# PRODUCT CHANGE NOTIFICATION

## Select Bourns® Shielded Power Inductors

### *Manufacturing Site Relocation and Process Automation*

IC24174

Existing marking and gluing method (Partial coverage on core surface)	Revised marking & gluing method (Full coverage on core surface)

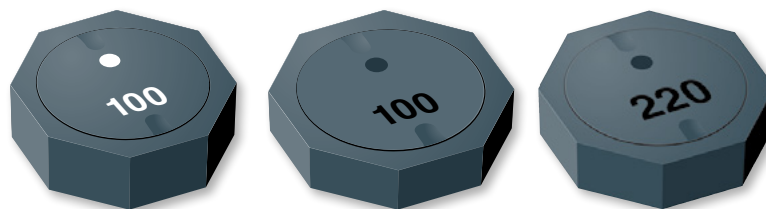
Bourns will also change its gluing, marking, testing, and taping processes to automated processes. Additionally, the marking method will be changed from laser to inkjet and the gluing method will have a larger application area. A list of affected part numbers is included below.

The fit, function and country of origin of the affected part numbers will remain the same. The form will change slightly due to the change to the marking method. The quality and reliability of the affected inductors should be improved as a result of the changes. Traceability will be maintained through lot code and date code.
